Terminology Input

In Support of Comments #47, 48, 49, 51, 53, 56

John D'Ambrosia,
Futurewei, US Subsidiary of Huawei
IEEE P802.3ct Task Force Meeting
Kona, HI, USA
Nov 2019

DWDM Link Types and Terminology

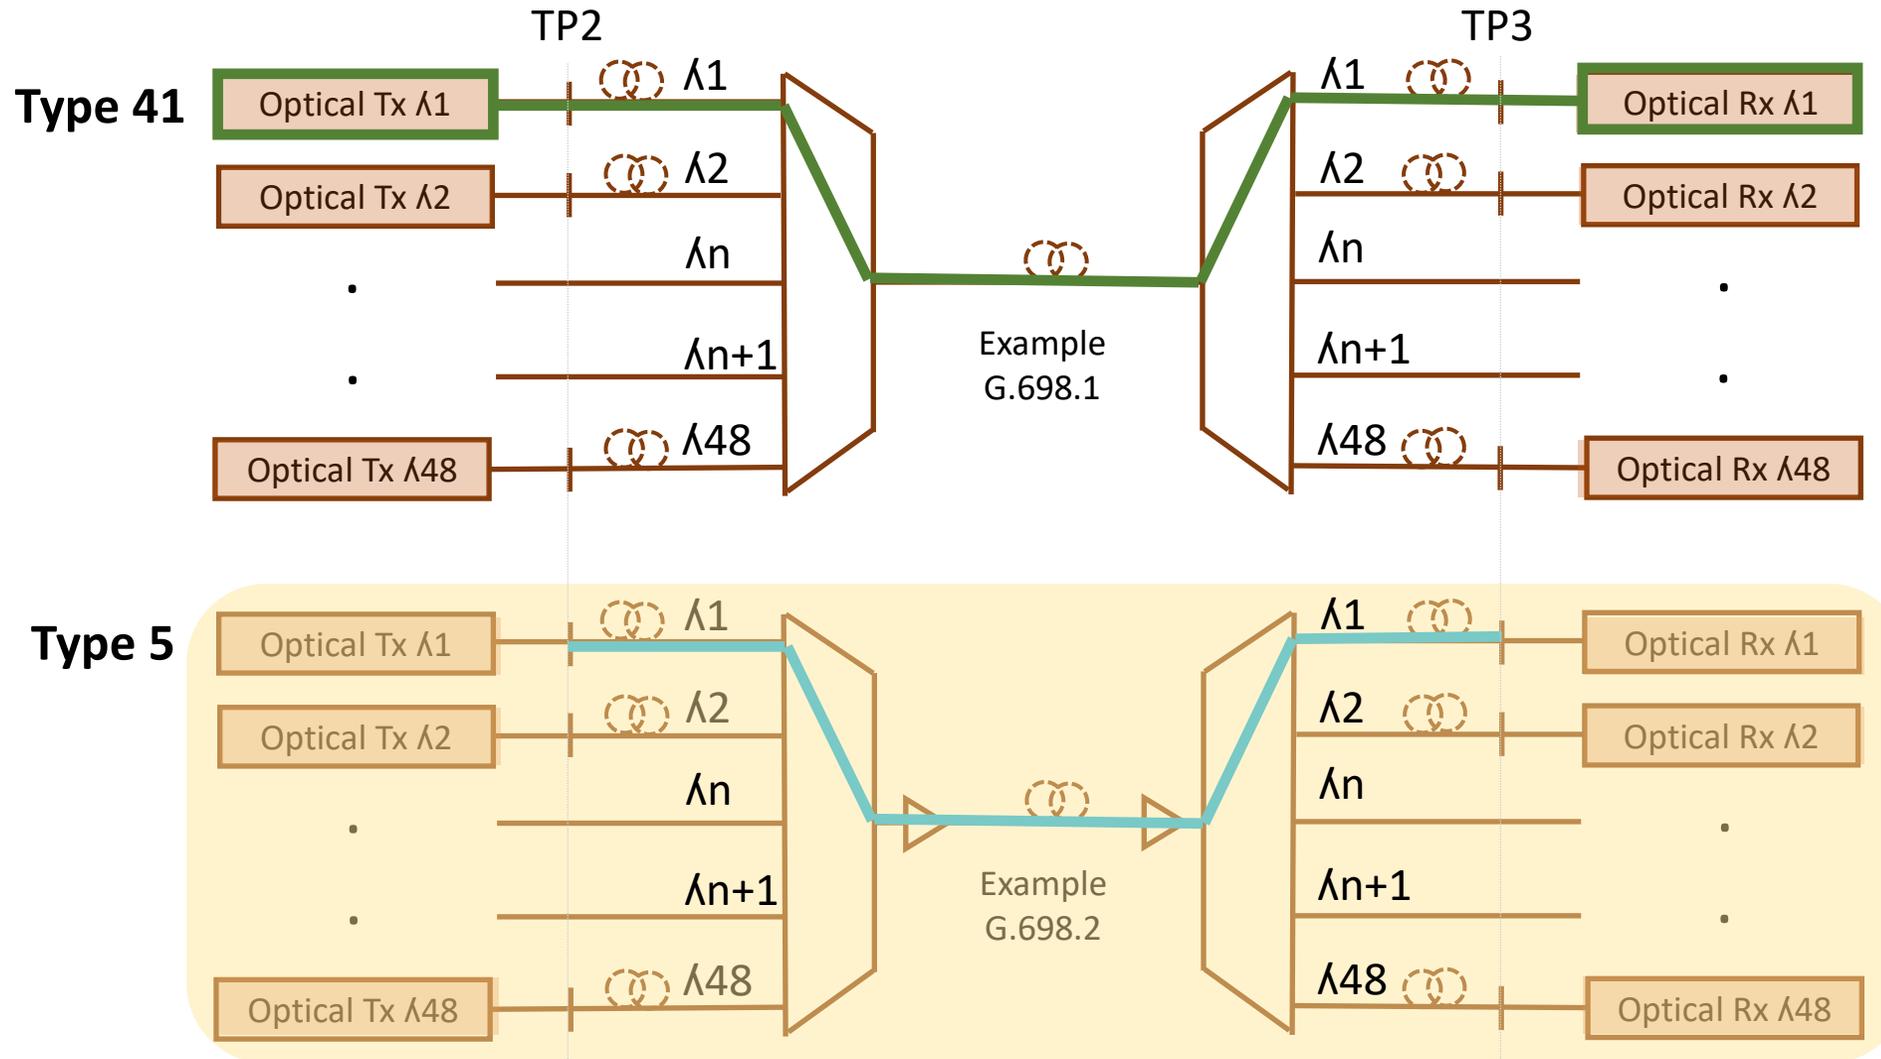
- **Comments submitted noted lack of terminology**
 - **47: DWDM System is not defined**
 - **49: "black link" is not defined**
 - **51: DWDM link is not defined**
 - **53: add a definition for DWDM PHY**
 - **56: Add definition - DWDM Network**
- **Some definitions have been agreed to previously by Beyond 10km Study Group "Terminology" Ad hoc**
(http://www.ieee802.org/3/B10K/public/18_03/dambrosia_b10k_01_0318.pdf)

Figure 154–3—Block diagram for black link specification approach

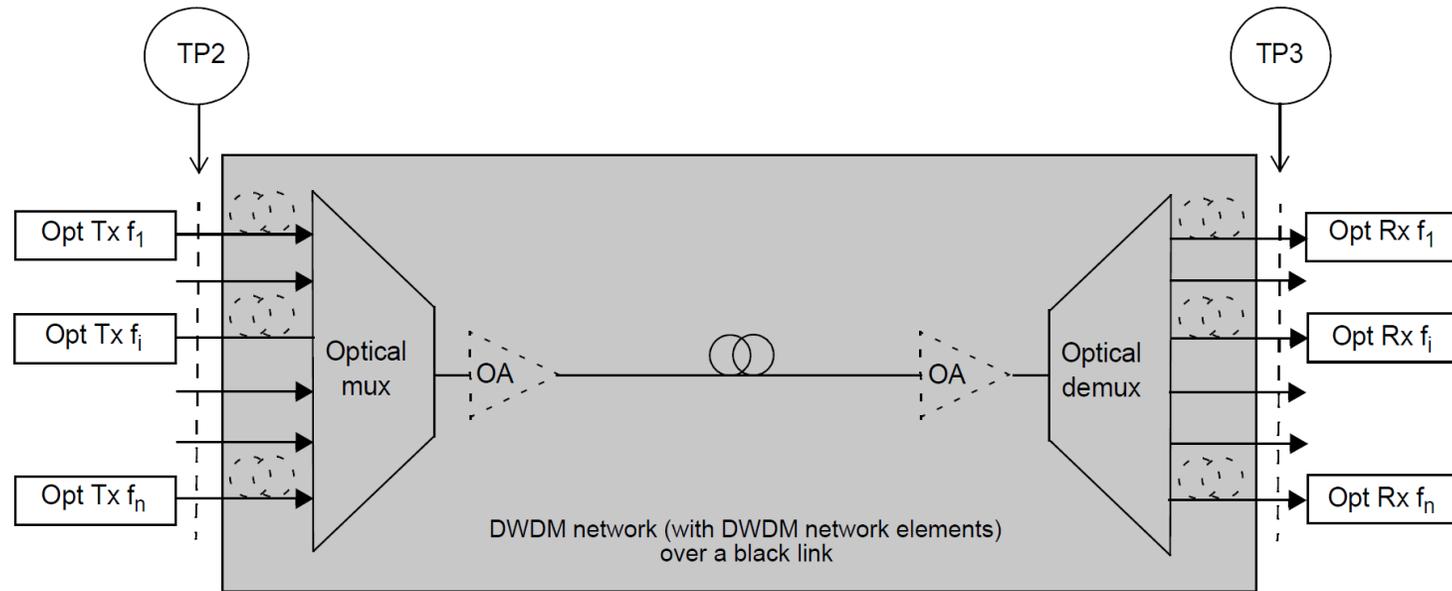
In Fig 154-3 – a DWDM Network has been drawn essentially as a DWDM system minus the DWDM PHYs. Between PHYs is the DWDM Channel – so the DWDM network is the summation of all of the DWDM channels

Add to 1.4: DWDM Network – The aggregate of DWDM Channels associated with a given DWDM system.
